Work Order ID 83804

Item Name: Crosstube Turning Detail

DRAWING NO.
D407-667-245
REV. F
SHEET 1 OF 4
TITLE
CROSSTUBE ASSY (407 HIGH AFT)
SCALE
NTS

DRAWING NO. D407-667-245	TITLE CROSSTUBE ASSY (407 HIGH AFT)	REV. F	DART AEROSPACE LTD ENGINEERING ORDER		D.E.O. NO. D407-667-245-F-1	SHEET NO. SHEET 1 OF 2	SCALE NTS
DRAWN <i>1</i>	CHECKED <i>9</i>	MFG. APPR. <i>E</i>	APPROVED <i>160</i>		DE APPR. <i>H</i>		
DATE 11.04.08	DATE 11.04.12	DATE 11.04.12	DATE 11.04.12		DATE 11.04.12

D407-667-245
ASSEMBLY DETAIL
(VIEW LOOKING FORWARD)

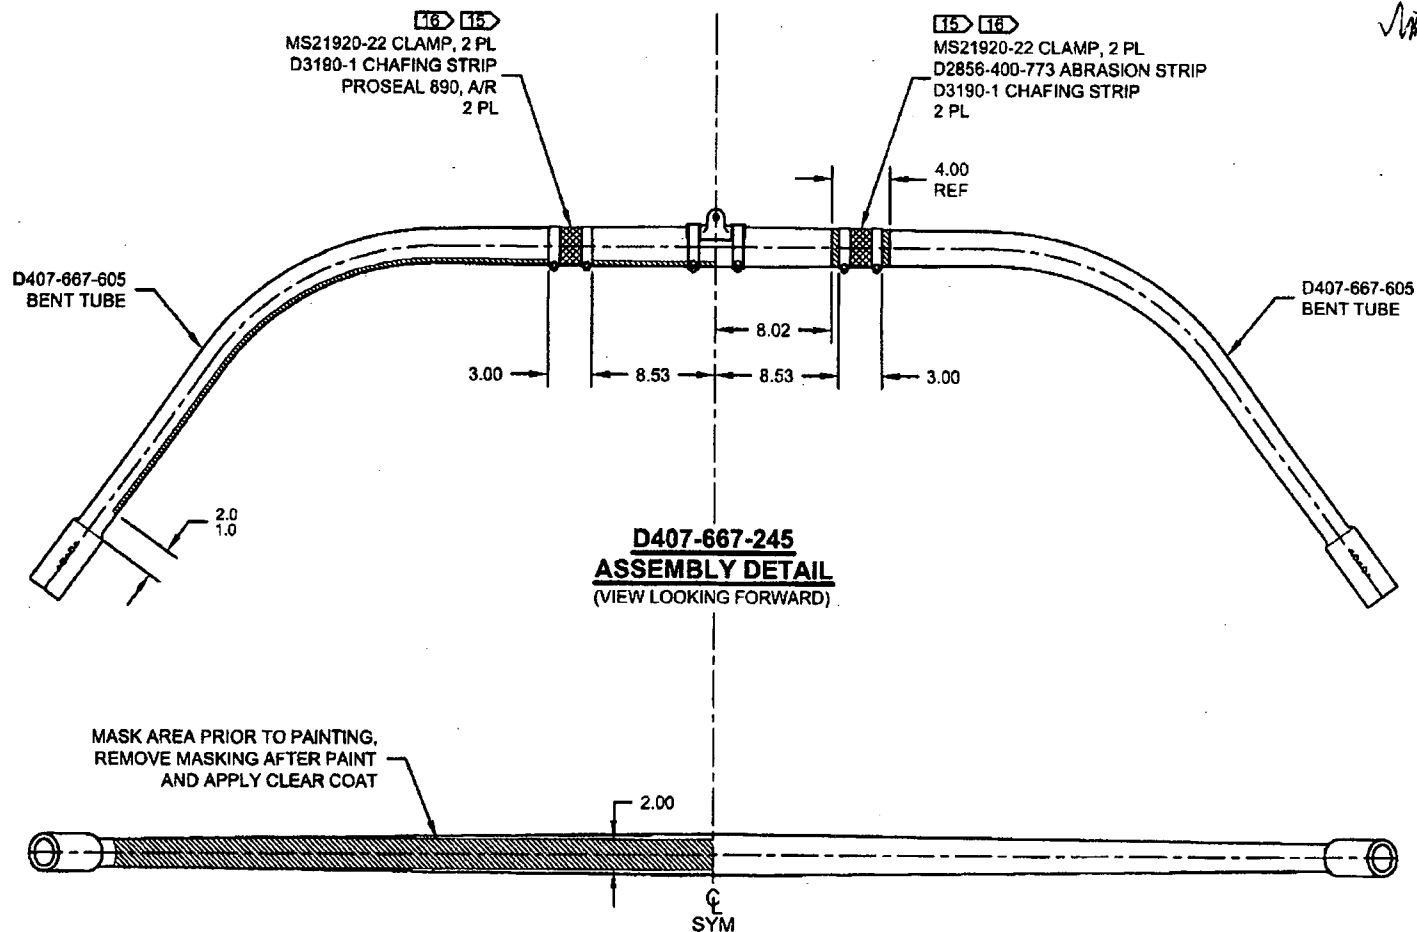
PURPOSE:

REMOVED ABRASION STRIP IN FAVOR OF A THIN LAYER OF PROSEAL 890.

NOTES 2 AND 15, SHEET 1 ARE AMENDED AS FOLLOWS:

- 2) FINISH: CHEMICAL CONVERSION COAT PER DART QSI 005 4.1
PRIME INSIDE AND OUTSIDE PER DART QSI 005 4.2
MASK UNDERSIDE OF CROSSTUBE AS SHOWN (HATCHED AREA) AND
PAINT OUTSIDE PER DART QSI 005 4.2
REMOVE MASKING AND APPLY CLEAR COAT
- 15) APPLY A THIN COAT OF PROSEAL 890 ON INSIDE CONCAVE SURFACE OF D3190-1
CHAFING SHIELDS AND LET CURE PER MANUFACTURER'S INSTRUCTIONS. INSTALL
PROSEALED D3190-1 CHAFING SHIELDS ONTO CROSSTUBE BY APPLYING A THIN COAT
OF PROSEAL 890 ONTO CROSSTUBE. BE SURE TO ELIMINATE ANY AIR GAPS.

- 2) FINISH: CHEMICAL CONVERSION COAT PER DART QSI 005 4.1
PRIME INSIDE AND OUTSIDE PER DART QSI 005 4.2
PAINT OUTSIDE PER DART QSI 005 4.2
- 15) INSTALL D2856-400-773 ABRASION STRIP WITH A 0.13 REF GAP ON BOTTOM SIDE OF
CROSSTUBE PER QSI 035.
